To: All Interested Bidders and Plan Holders
From: Jennifer Steed, Senior Project Manager
RE: Lake Myra County Park Phase 1 (RFB#26-077)
Addendum No. 1
Date: September 18, 2026

Lake Myra County Park Phase 1

Addendum No. 1

SUBJECT: ADDENDUM NO. 01 **09/26/2026**

MF-E101

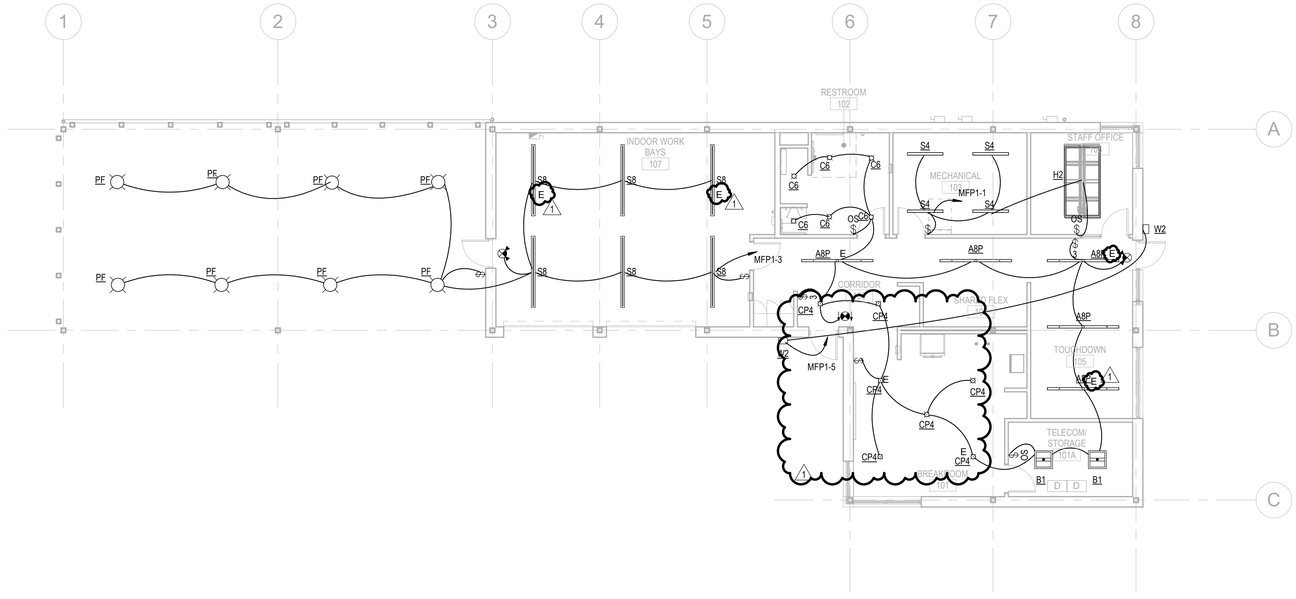
4. Sheet MF-E101: See attached revised sheet. Revisions include:
   a. Light fixture designation corrected from “CP1” to “CP4”.
   b. Egress light battery units added.

c. Tag location for PV disconnect switch corrected.
   d. Added tag for PV inverter.
   e. Added PV circuit to MFP1 panel schedule.
5. Sheet WS-E001: 4/ WS-E001 Revise circuit from panel WPS to PV inverter to indicate 3#8, 1 #8G in ¾”C.
